Thank you for the presentation on the 18th of January along with the consultants Sheridan Woods.

Summary

User Hierarchy For Irish Towns

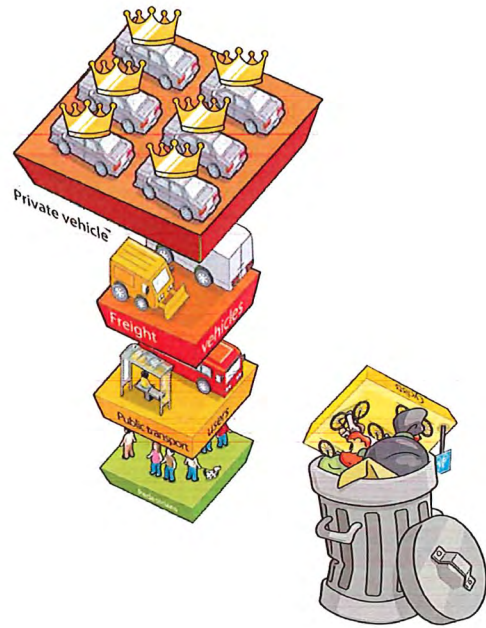
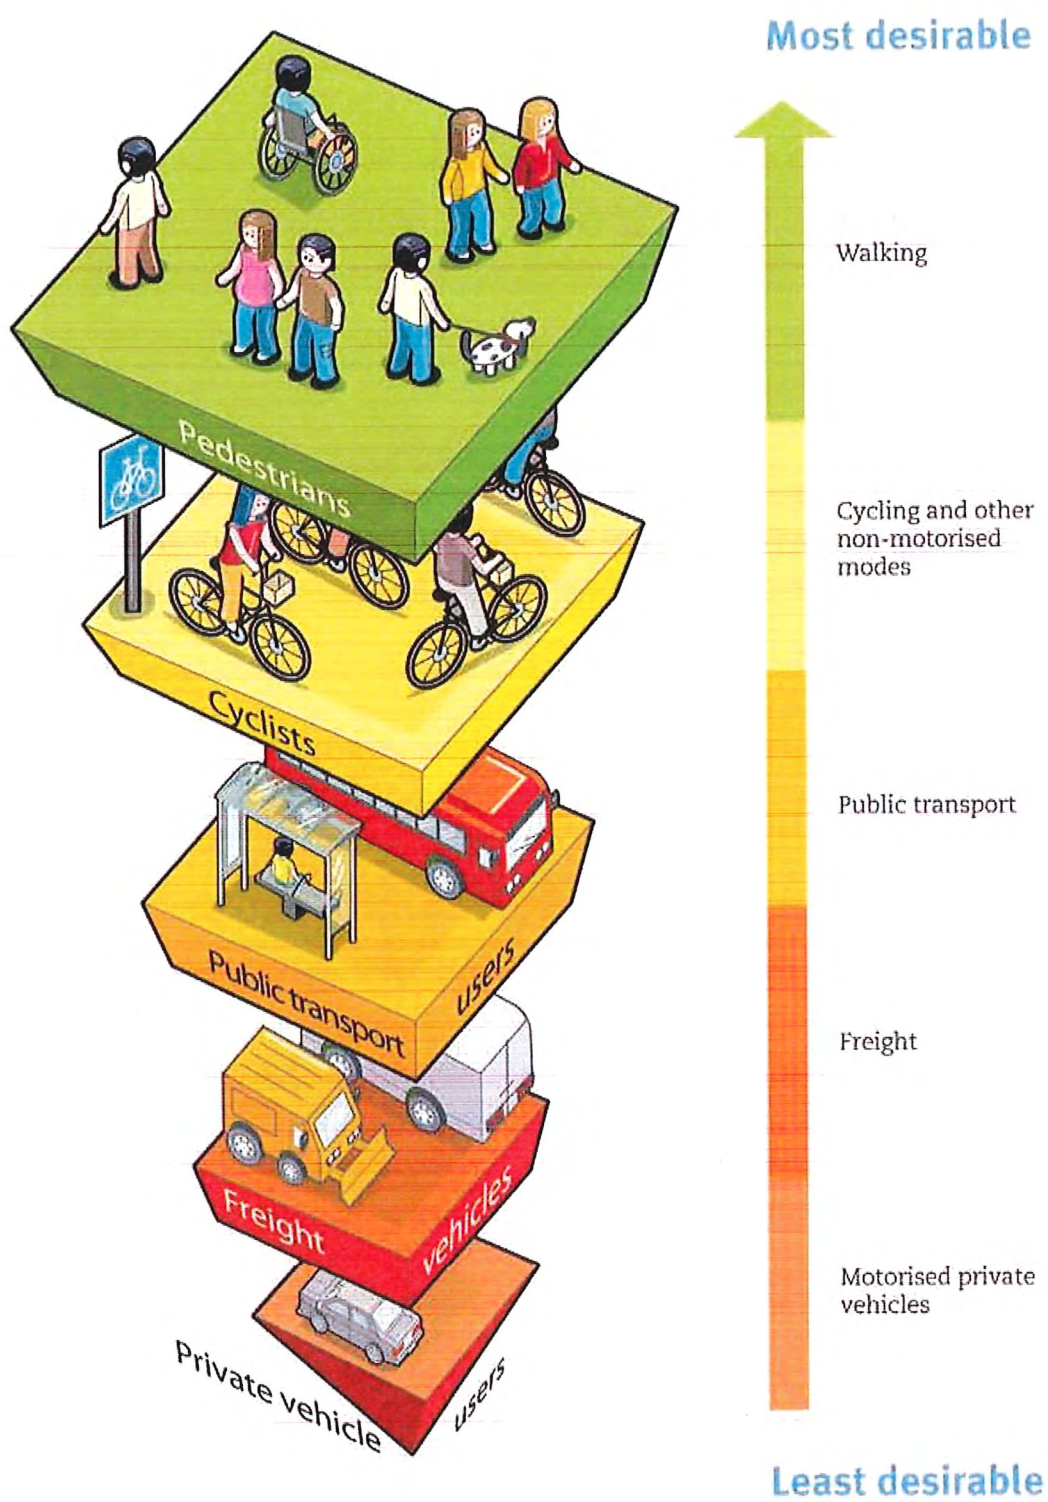
While the plans objectives, goals, vision and background research is generally very agreeable and is everything that a progressive Master Plan should contain, unfortunately the manifestation of this vision into both the Master Plans fails badly. The end result is something that looks more like a vehicle transport plan leading to car parks with various types of building as opposed to a Master Plan which was developed from the person first. The end result will be an increase in the traffic through the town, a significant increase in the traffic through old cross square and no uplift for the regeneration of Dublin Street. The Master Plan falls flat and is a major disappointment from its potential to be a blue print not just for Monaghan but for other towns of similar size in the Country. What is drawn is outdated and not in keeping with the vision of 10 minute towns or people centred design. – When you look at the amount of roads, the amount of parking at each building and the potential proposed additional roads you will see that this plan most defiantly still falls under the 'User Hierarchy For Irish Towns' in the graphic below.

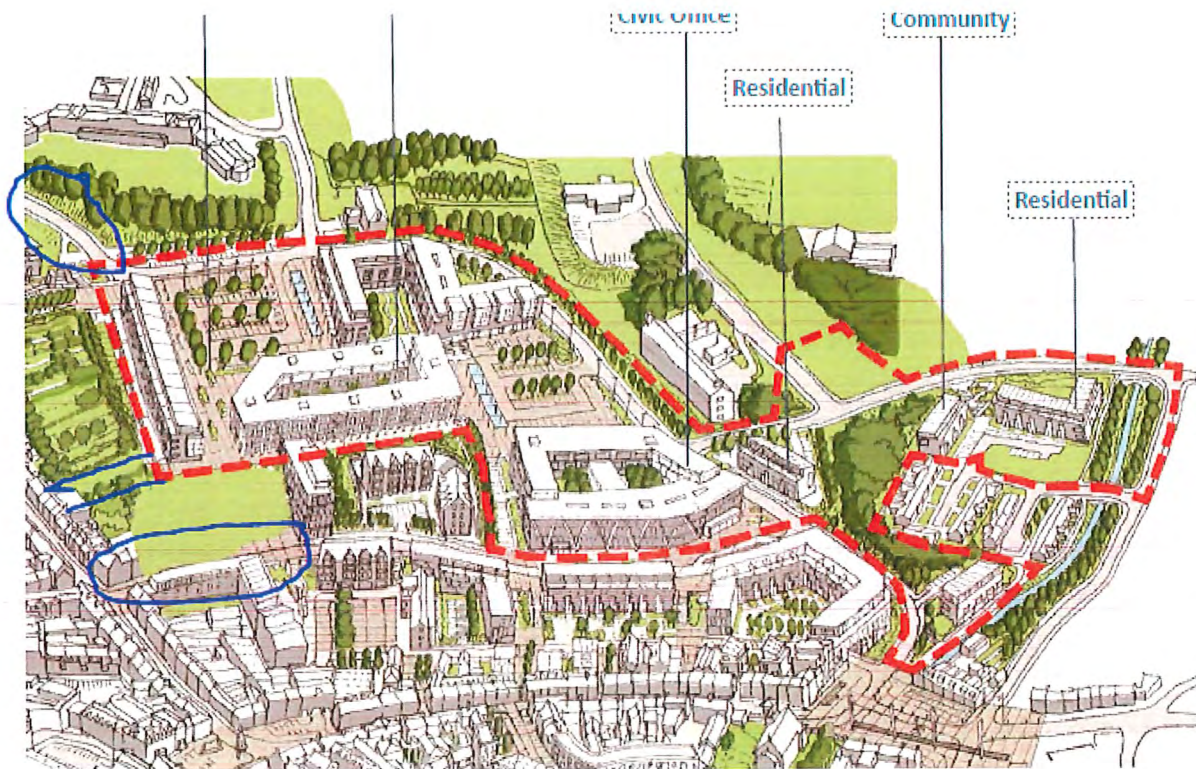
Both of these objectives are the same, connecting the masterplan site to Glaslough Street. With such a vehicle movement dominated plan and with the plan already indicating connecting Infirmary hill to Glaslough Street, you can see the future knocking of buildings to create roads into the development. All of which will negatively impact on the liveability of this development and the town. This is a major concern of this masterplan, it basically creates another ring road around the town.

Streets, Routes and Links

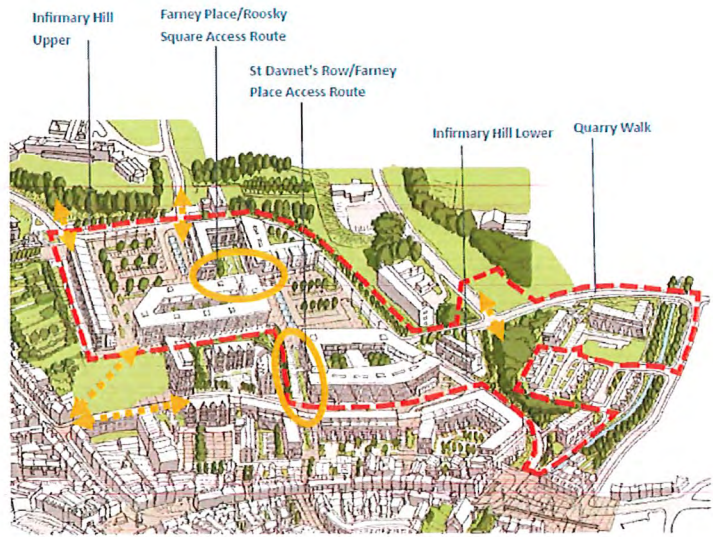
Your know your master plan is fundamentally flawed when you have to identify Pedestrian Access Routes, the rest is vehicle prioritised.

Images of Real Master Plan

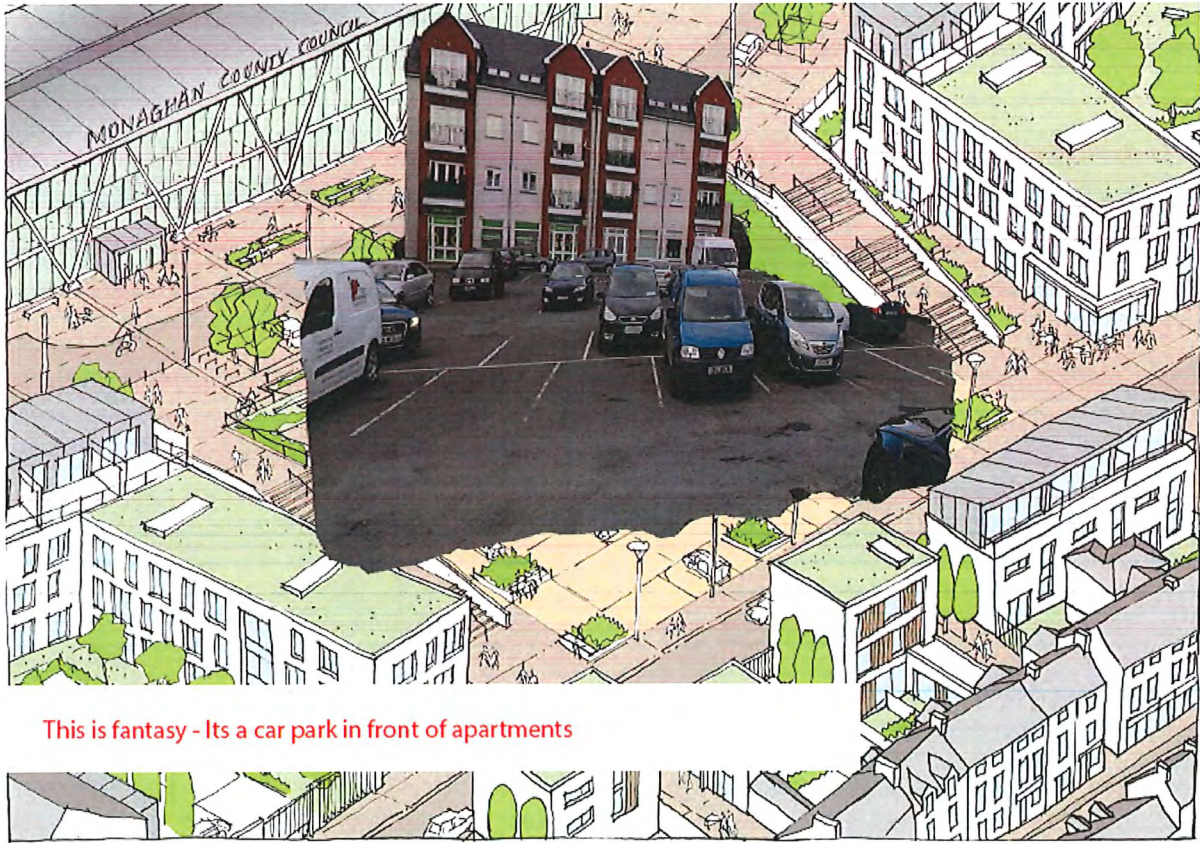
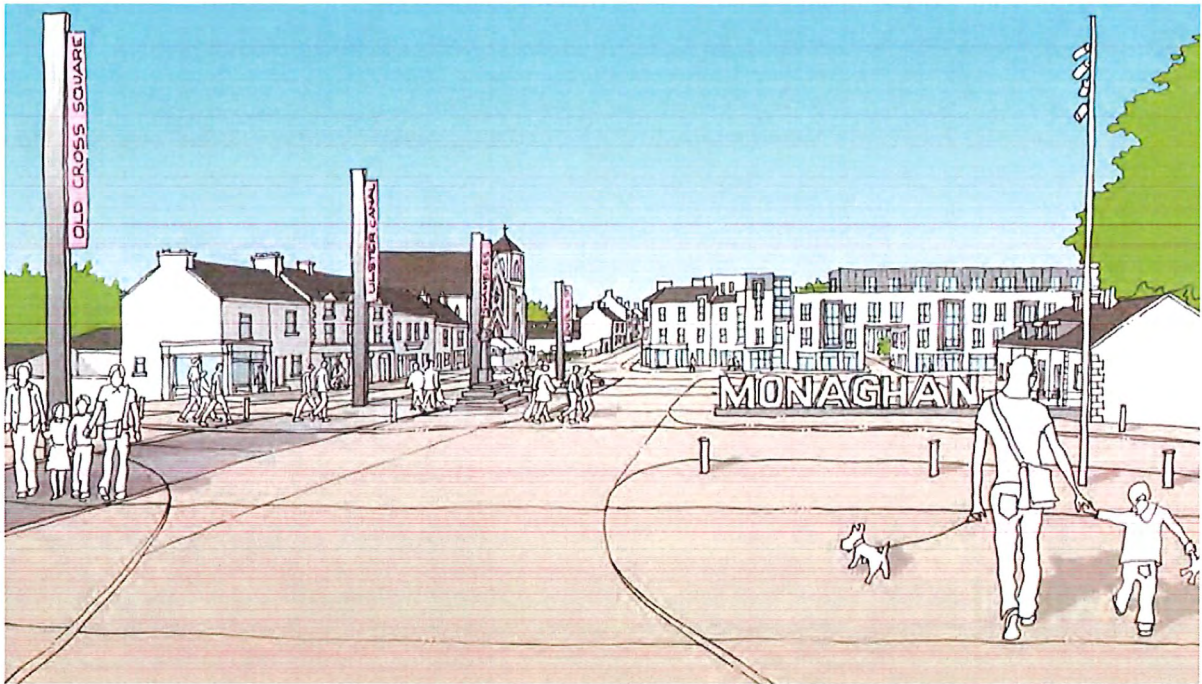
Old cross square with new roads and increase traffic will look like the above!!!!!!!!!!!!!!!!!!!!!!

Old cross square at 2pm on a Tuesday in January.
